# Technical Service Bulletin

## 57 Door cannot be opened from outside, it can only be opened from inside

57 14 99 2029151/5 January 3, 2014. Supersedes Technical Service Bulletin Group 57 number 13-87 dated March 27, 2013 for reasons listed below.

**Figure 4.** Holding the yellow sleeve in the lock.

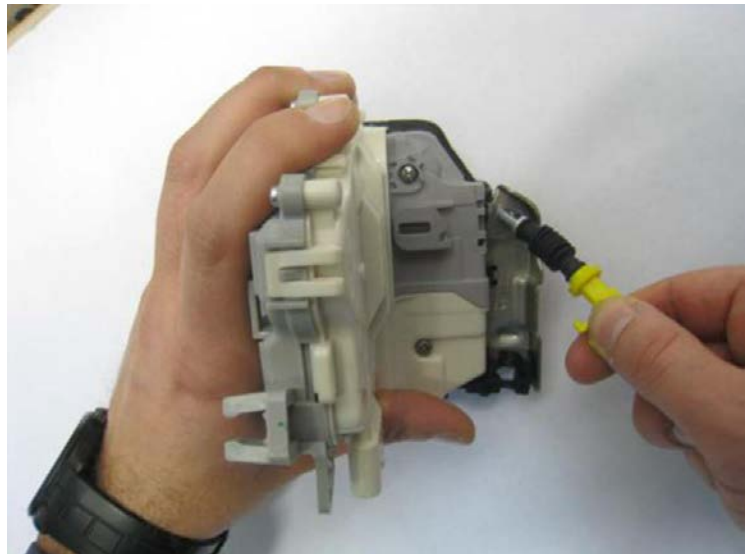
- a. Position the Bowden cable by holding the yellow sleeve in the lock (Figure 4).

*Figure 6. Do not turn the lock or the mounting bar.*

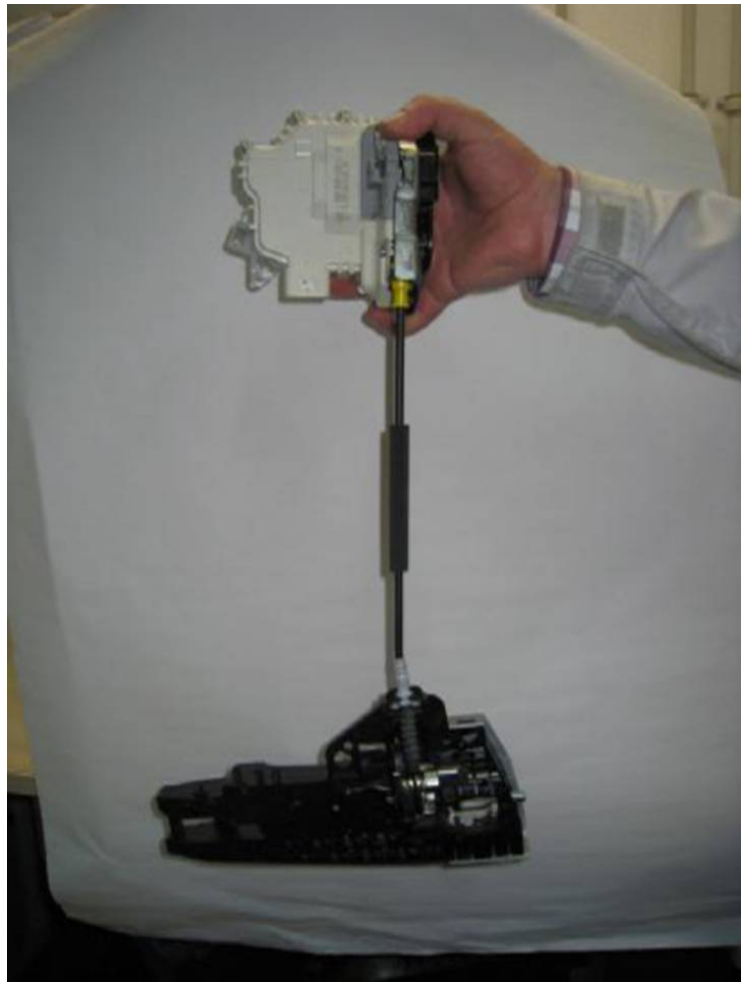
- c. Do *not* twist the Bowden cable after the installation. To avoid twisting the cable, turn neither the lock nor the mounting bar (Figure 6).
